## Product Change Notification / SYST-10KFAZ971

ERRATA - dsPIC33CH128MP508 Family Silicon Errata and Datasheet Clarification

## dsPIC33CH128MP508 Family Silicon Errata and Data Sheet Clarification

**FIGURE 1: I/O RAMP**

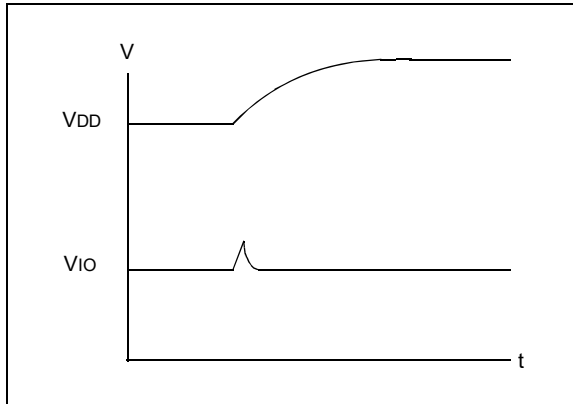
During a fast device power-up, when the VDD ramp is less than 4 mS, the I/O pins may drive up to 100  $\mu$ A current for a duration of up to 10  $\mu$ S (Figure 1).

1. Slow down the VDD ramp time (greater than 4 mS for VDD to ramp 0V to 3.3V).
2. Ensure the circuitry that is connected to the pins can endure this pulse.

Example applications affected may include complementary power switches, where a transient current shoot-through might occur.

High-voltage applications with complementary switches should power the high-voltage 200  $\mu$ Sec later than powering the dsPIC<sup>®</sup> device to avoid the current shoot-through. This behavior is specific to each device and not affected by aging.

**FIGURE 2-2: SUGGESTED PLACEMENT OF THE OSCILLATOR CIRCUIT**

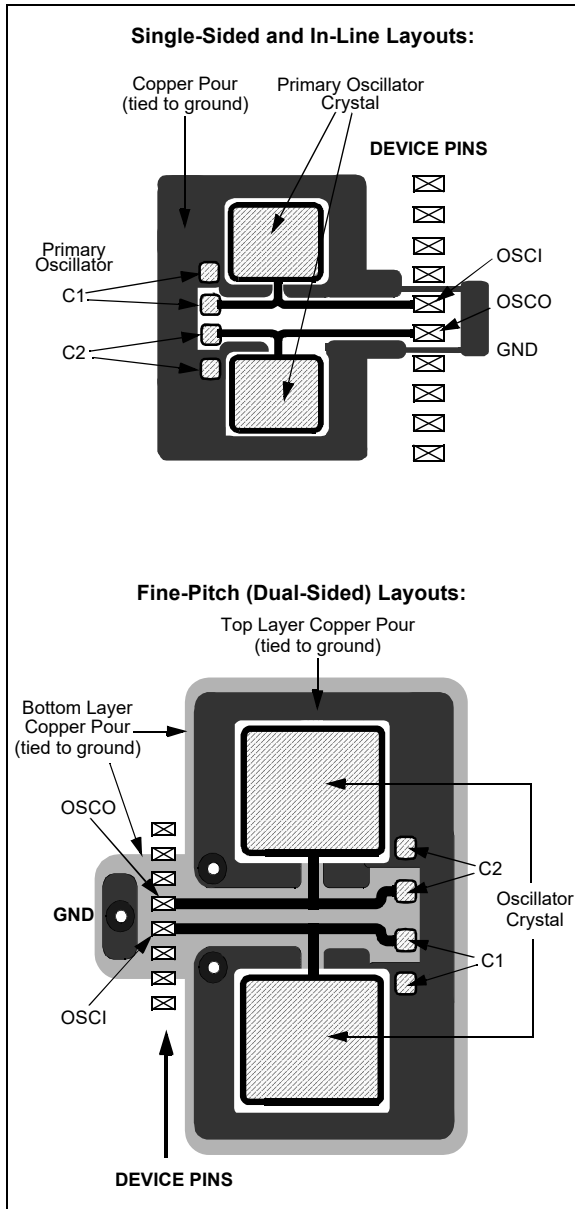
Additional information is added to [Section 2.5 “External Oscillator Pins”](#) and [Section 2.6 “External Oscillator Layout Guidance”](#) is added.

#### 2.6 External Oscillator Layout Guidance

Use best practices during PCB layout to ensure robust start-up and operation. The oscillator circuit should be placed on the same side of the board as the device. Also, place the oscillator circuit close to the respective oscillator pins, not exceeding one-half inch (12 mm) distance between them. The load capacitors should be placed next to the oscillator itself, on the same side of the board. Use a grounded copper pour around the oscillator circuit to isolate it from surrounding circuits. The grounded copper pour should be routed directly to the MCU ground. Do not run any signal traces or power traces inside the ground pour. If using a two-sided board, avoid any traces on the other side of the board where the crystal is placed. Suggested layouts are shown in [Figure 2-2](#). With fine-pitch packages, it is not always possible to completely surround the pins and components. A suitable solution is to tie the broken guard sections to a mirrored ground layer. In all cases, the guard trace(s) must be returned to ground.

**FIGURE: ADC ANALOG INPUT MODEL**

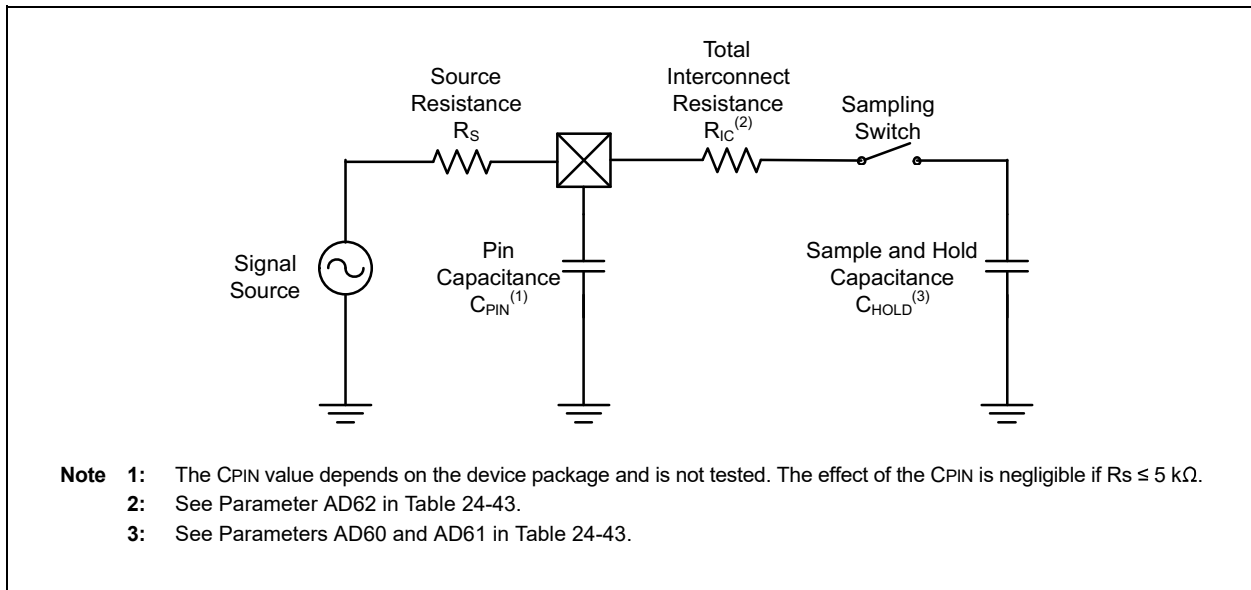
The following **Sampling Time Requirements** section has been added to both **Section 3.9 “High-Speed, 12-Bit Analog-to-Digital Converter (Main Core ADC)”** and **Section 4.7 “High-Speed, 12-Bit Analog-to-Digital Converter (Secondary Core ADC)”**.

The total acquisition time for the Analog-to-Digital conversion is a function of the Holding Capacitor ( $C_{HOLD}$ ) charge time. For the ADC module to meet its specified accuracy, the Holding Capacitor ( $C_{HOLD}$ ) must be allowed to fully charge to the voltage level on the analog input pin. The Signal Source Impedance ( $R_S$ ) and the Interconnect Impedance ( $R_{IC}$ ) combine to affect the time required to charge the  $C_{HOLD}$ . The total resistance ( $R_S + R_{IC}$ ) must therefore, be small enough to fully charge the Holding Capacitor within the selected sample time.
